# UNITED STATES PATENT AND TRADEMARK OFFICE

APPLICATION NO.	FILING DATE	FIRST NAMED INVENTOR	ATTORNEY DOCKET NO.	CONFIRMATION NO.
10/559,802	03/26/2007	Fritz-Peter Pleschiutchnigg	HM-675PCT	7340
40570	7590	04/27/2009		
FRIEDRICH KUEFFNER 317 MADISON AVENUE, SUITE 910 NEW YORK, NY 10017			EXAMINER MCGUTHRY BANKS, TMA MICHELE	
			ART UNIT	PAPER NUMBER
			1793	
			MAIL DATE	DELIVERY MODE
			04/27/2009	PAPER

<b>Office Action Summary</b>	<b>Application No.</b> 10/559,802	<b>Applicant(s)</b> PLESCHIUTSCHNIGG ET AL.	
	<b>Examiner</b> TIMA M. MCGUTHRY-BANKS	<b>Art Unit</b> 1793

**Fig. 1**

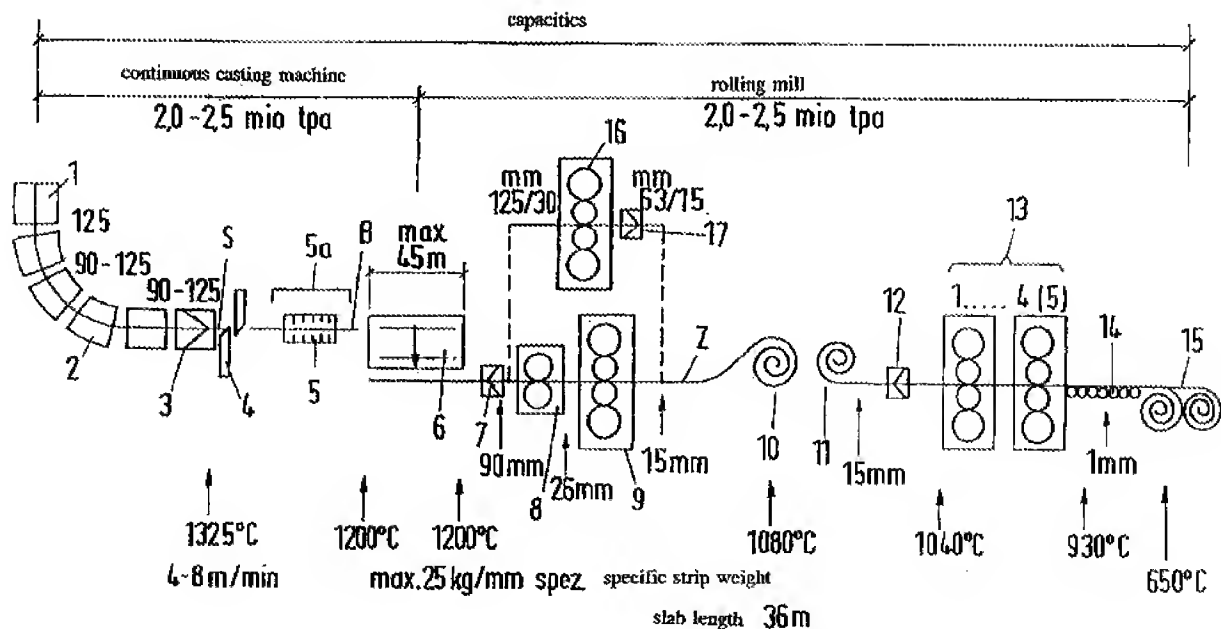
Pleschiutchnigg et al '991 teaches producing hot-rolled steel strip from input stock of continuously cast strip in sequential work steps (abstract) as shown below in Fig. 1:

The steel is in strips (abstract). The cast steel is reduced in thickness at 2, cut at 4, descaled at 7, heated at 16, heated at 6, descaled at 7, rolled at 8 and 9, coiled at 10, cooled at runout table at 14

and coiled at 15. Regarding Claims 9 and 10, the run-out table includes a cooling device (column 3, lines 50-52). Applicant does not provide any limitation to how the cooling is controlled in Claim 10.

However, Pleschiutchnigg et al '991 does not teach descaling after casting as in Claims 1 and 6, descaling after cutting as in Claim 1, a soaking furnace in Claim 1 or process route (a).

FIG. 1

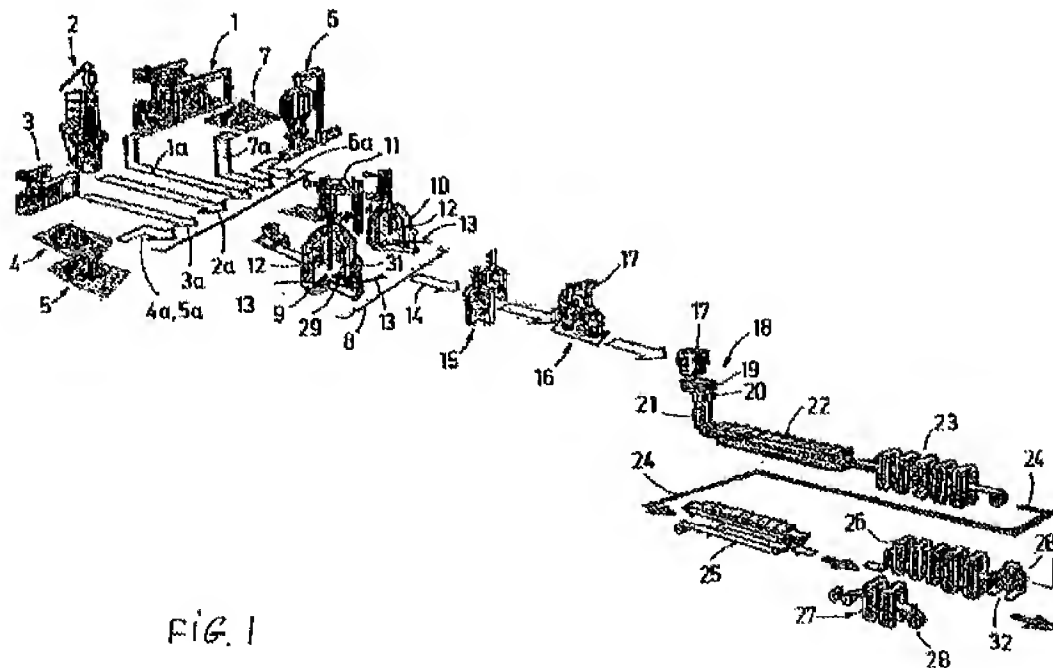
Regarding process route (b), Pleschiutchnigg et al '163 teaches producing steel in a plant as shown below in FIG 1:

The plant includes an electric arc furnace converter installation 8 with two metallurgical vessels 9 with electrode system 11 [0027], and the steel is delivered to a ladle to a continuous casting mold [0028]. The plant also includes a vacuum installation 15 (VD, VOD) [0037]. Further

regarding Claim 11, the electrode system pivots over each metallurgical vessel [0027].

Pleschiutchnigg et al '163 further teaches using pig iron and scrap [0026] and using top lances [0004]. An electric arc furnace inherently runs by electrical energy. It would have been obvious to one of ordinary skill in the art at the time the invention was made to use the steel production installations of Pleschiutchnigg et al '991 as taught by Pleschiutchnigg et al '163, since Pleschiutchnigg et al '163 teaches that two metallurgical vessels can be changed based on arbitrary analysis of following each other melts [0006].
